Condition 3 – Flood Risk Assessment (Pre-commencement)

Subject: Former Colt Industrial Estate, Barton Road, Havant [Filed 03 Jul 2020 20:20]

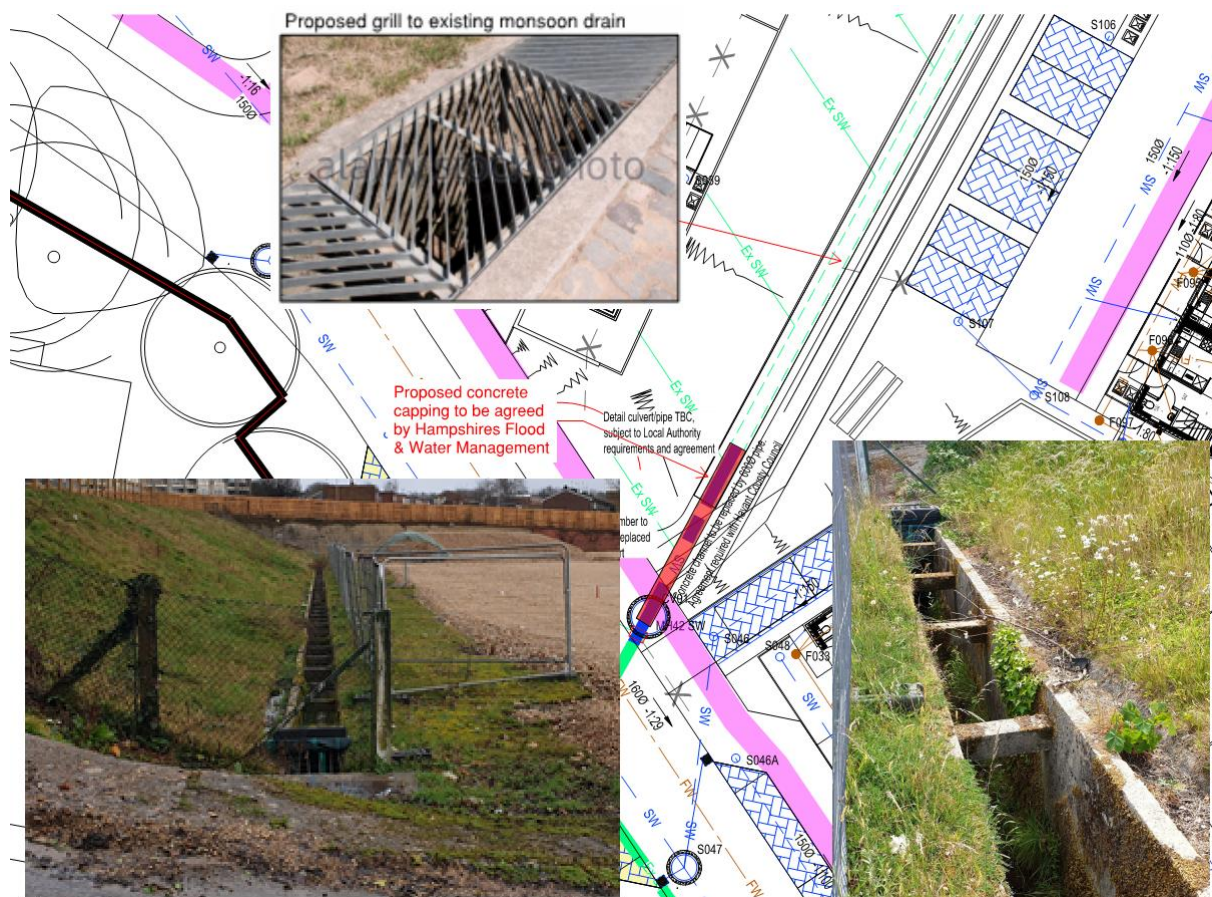
a) The condition of the monsoon drain within the application site, which shall be investigated and any required improvement carried out. Evidence of this, including photographs shall be submitted before any connection is made.

The monsoon drain is currently free running with small areas of vegetation.

Due to the new site levels, it is proposed to install a concrete cap over 8m of the monsoon drain to allow the site levels to work.

The remainder of the drain will be fitted with a steel grate for Health & Safety reasons, which will form part of the landscaping in this area.

Also attached is a drainage plan which shows part of the open concrete channel adjacent to Plot 01. Under our proposed new road it turns into a 600mm diameter pipe (the green line), but for the first couple of metres it is still an open channel, so we need to slab it this section over (as it will be under the road). We also need to install a grating on top of the open channel to prevent people falling into it.
